Well Name: COTTON DRAW UNIT	Well Location: T25S / R32E / SEC 10 / SWNE / 32.1461553 / -103.6596222	County or Parish/State: LEA / NM
Well Number: 102	Type of Well: OIL WELL	Allottee or Tribe Name:
Lease Number: NMLC061936	Unit or CA Name: COTTON DRAW DELAWARE	Unit or CA Number: NMNM70928A
US Well Number: 3002537598	Operator: CHEVRON USA INCORPORATED

Type of Submission: Subsequent Report      Type of Action: Plug and Abandonment

**As Plugged  
WELLBORE DIAGRAM**

**From:** [Immatty, Keith P](#)  
**To:** [Yousef, Sahdy](#)  
**Subject:** [\*\*EXTERNAL\*\*] Re: [EXTERNAL] CDU 102 CBL and Plan Proposal Sundry # 2841823  
**Date:** Wednesday, July 9, 2025 9:23:45 AM  
**Attachments:** [image001.png](#)

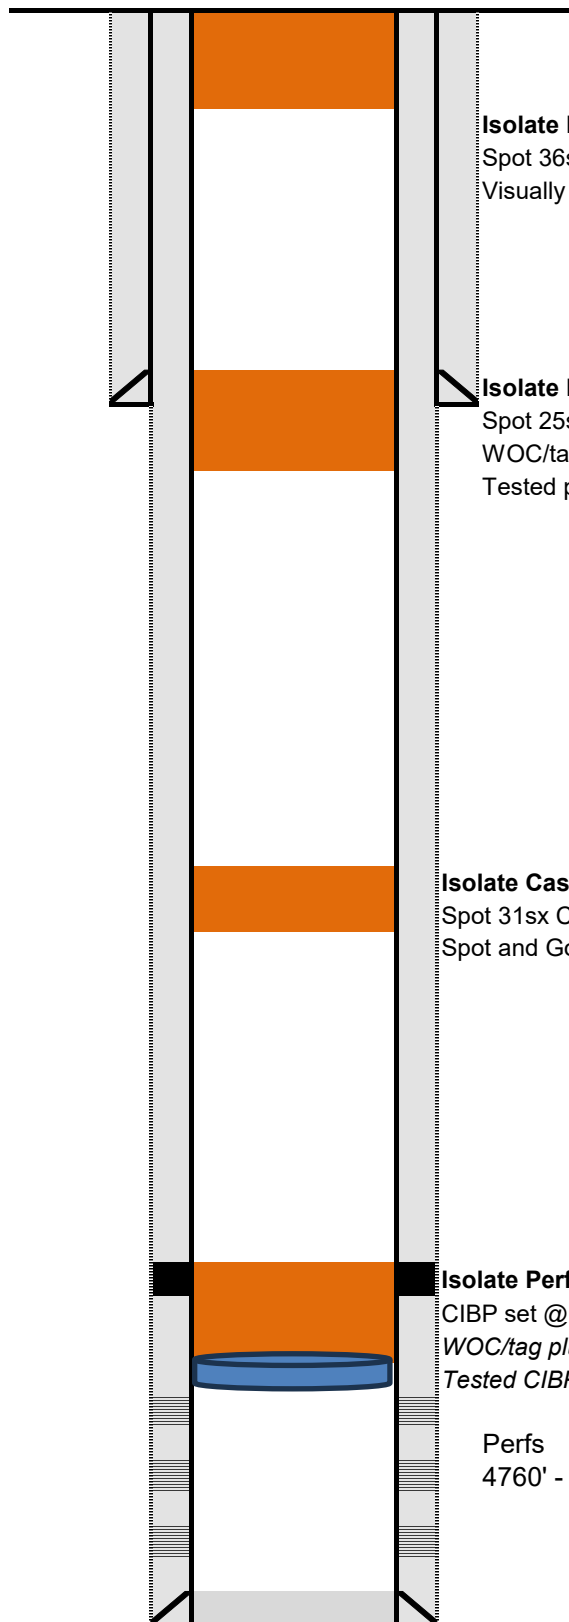
Hi Keith,  
perforating at 60' is a risk with our BP to shoot that shallow and I believe (have to confirm) Chevron does not allow to shoot <100' or 150'. the log at surface was still calibration mode that shallow. I do believe we have cement at surface. Also, we would top fill the casing once it's cut off.

are you ok not perforating and as mentioned we will top off cement once we'll head is cut.

Please split plug 4 into, spot from 350-60' and a perf and sqz from 60' to surface. Remaining procedure OK.

Spot 36sx Class C f/ 350' - 3'  
Visually confirm cement to surface in annulus

Reviewed and is OK.
